Art Museum Security and Access Control Bldg. 534
Project No. FM110546S/987775

Addendum No. 1

ADDENDUM NUMBER 1

Art Museum Security and Access Control, Bldg. 534

VIDEO SURVEILLANCE SYSTEM RISER DIAGRAM

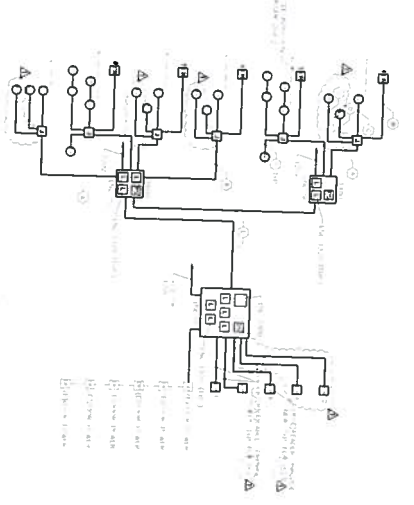
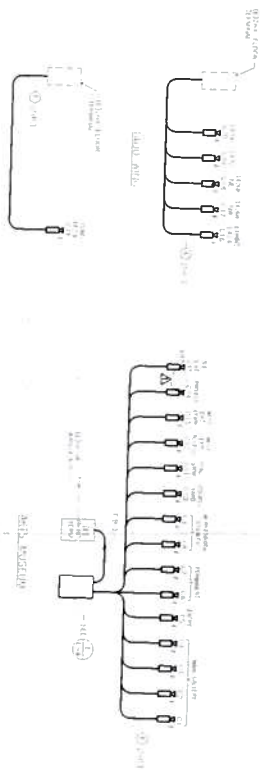
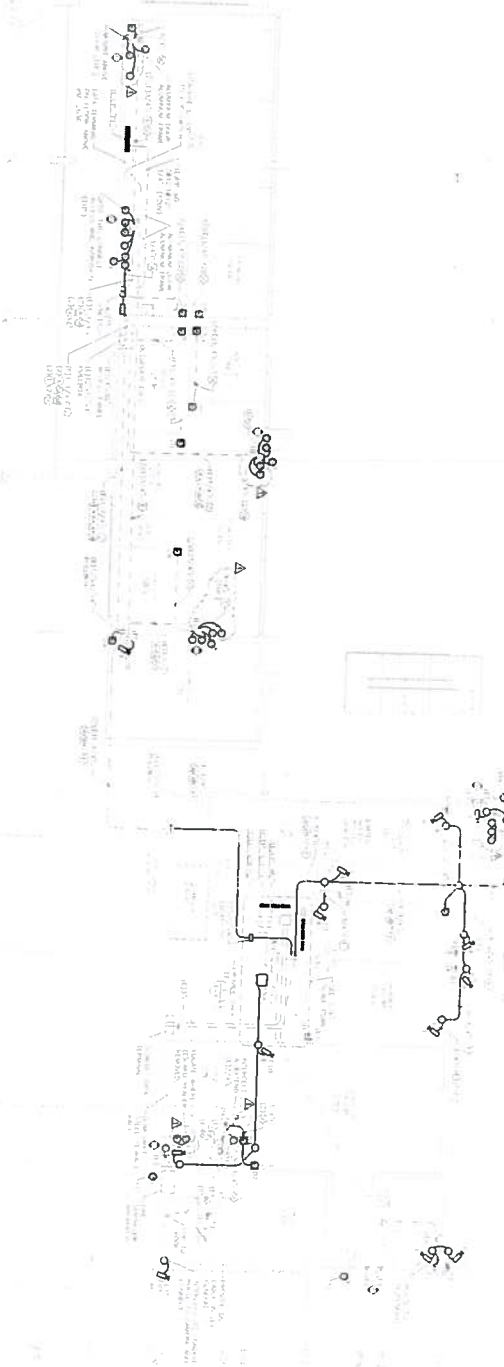
1. Sheet E-1.1 – Riser Diagrams, **Replace** in it's entirety with attached, “E-1.1 – Riser Diagrams, dated 9/6/11.

SHEET: ELECTRICAL FLOOR PLAN
 OF: E-3

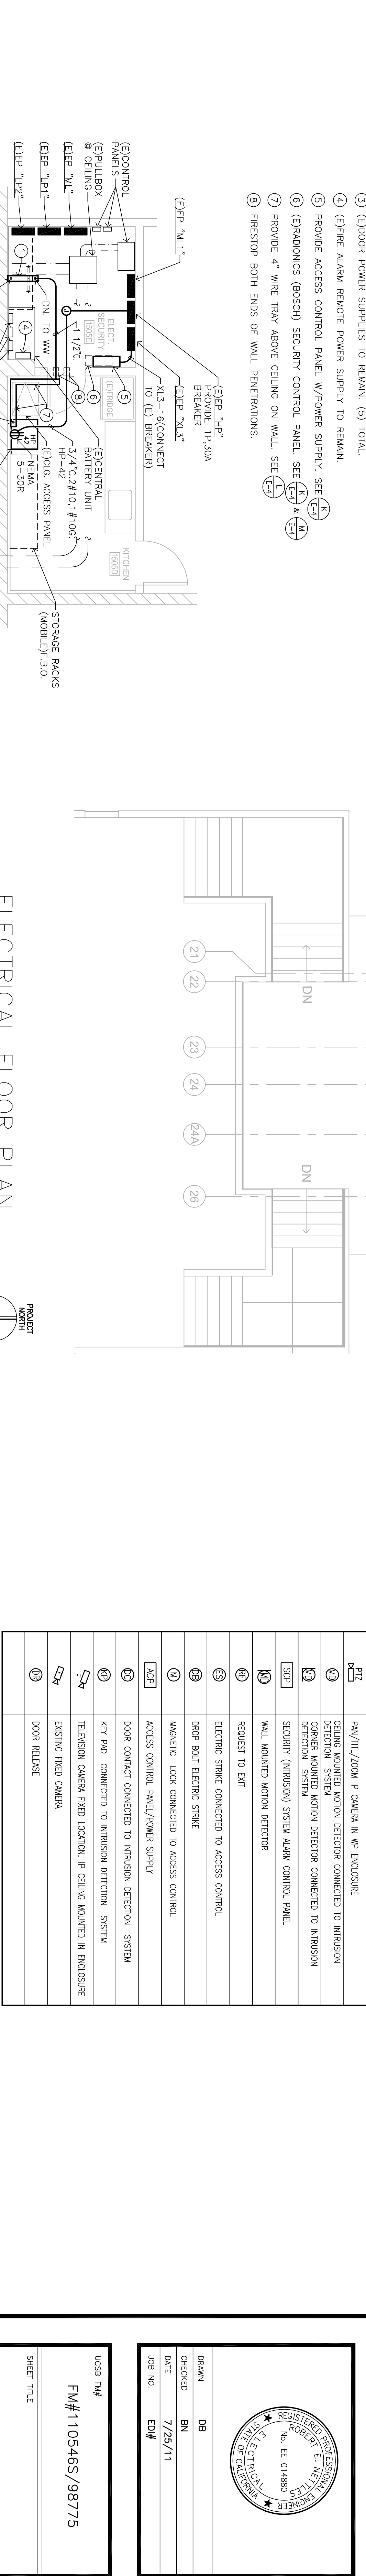
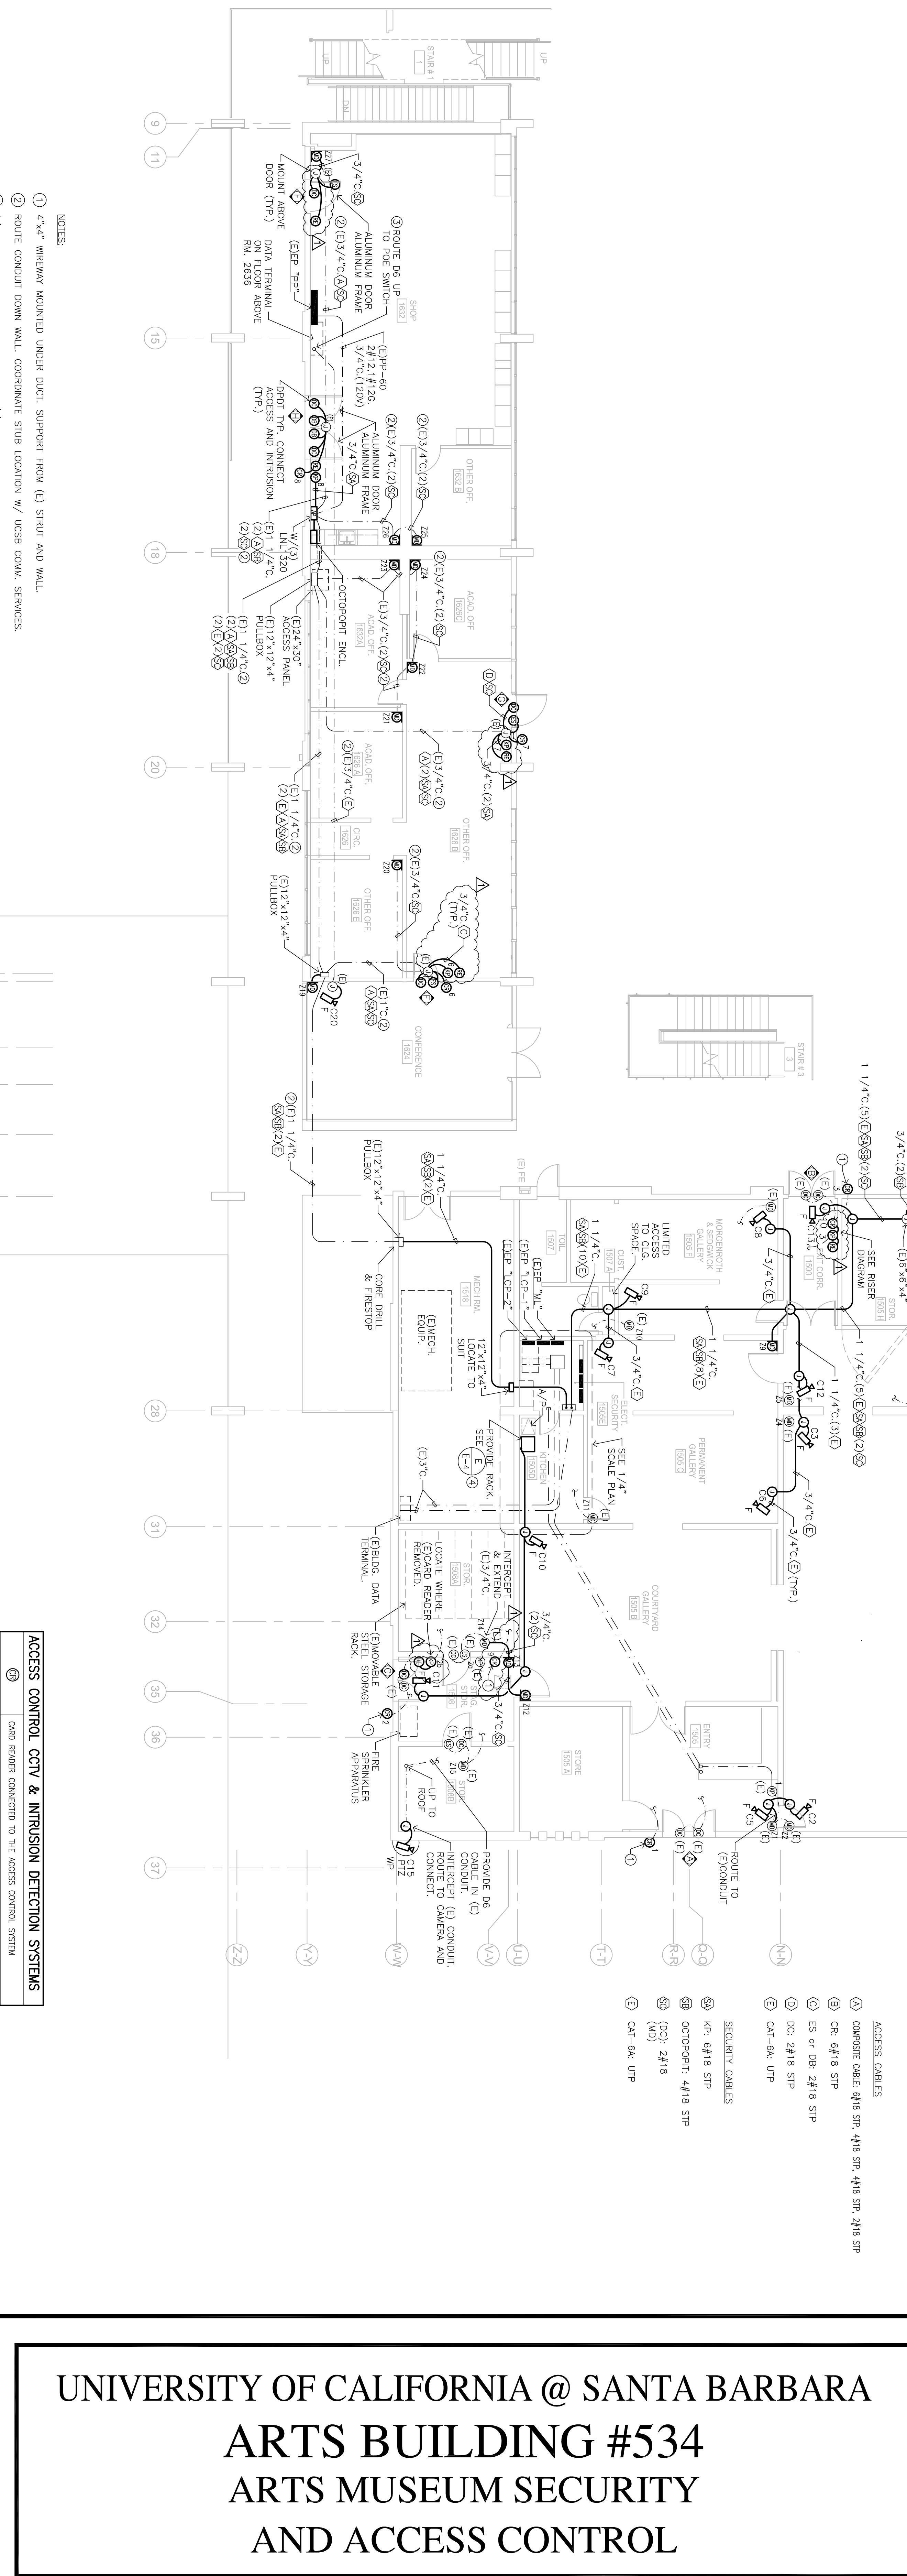
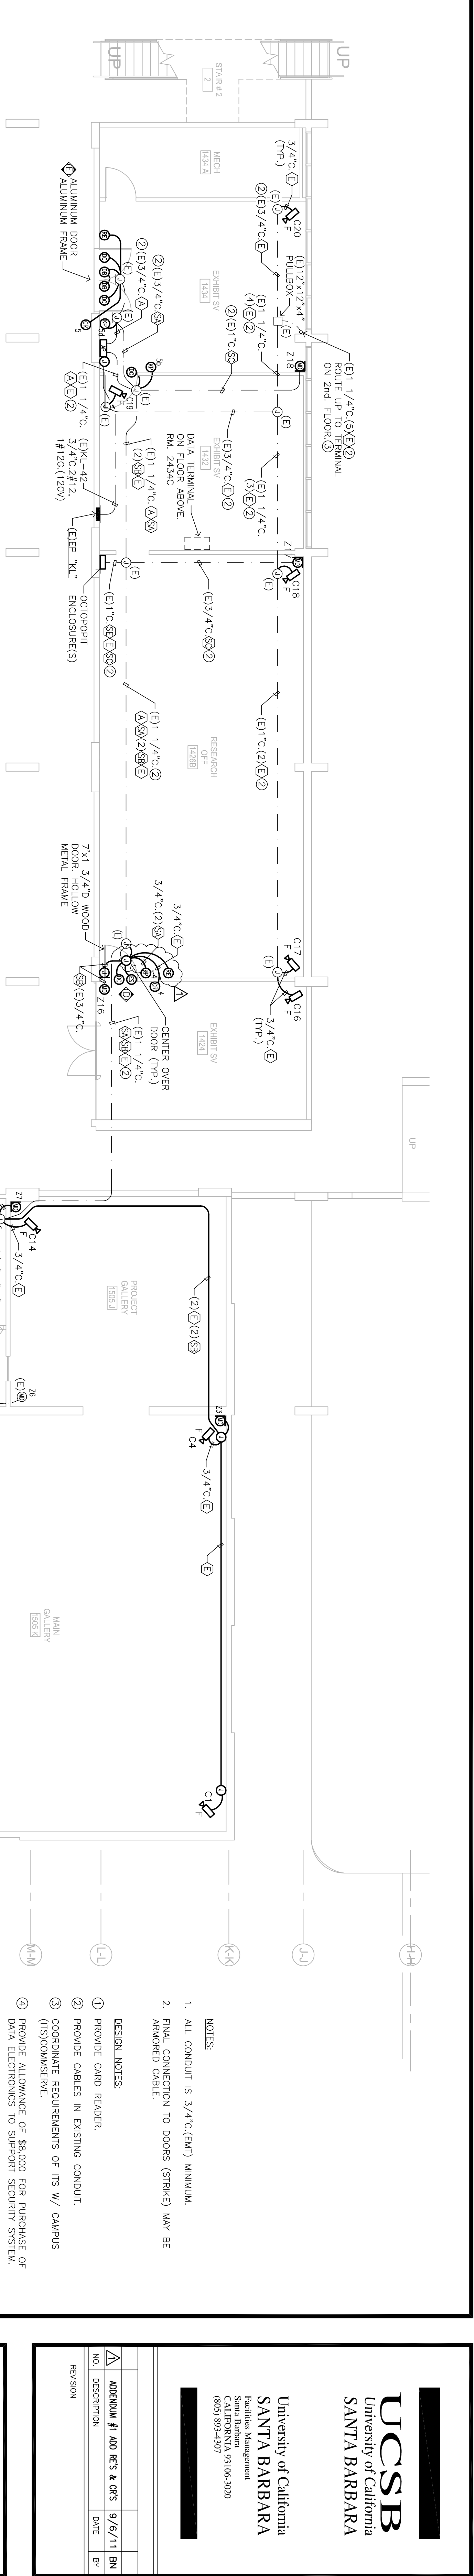
2. Sheet E-3 – Electrical Floor Plan, **Replace** in it's entirety with attached, “E-3 – Electrical Floor Plan, date 9/6/11.
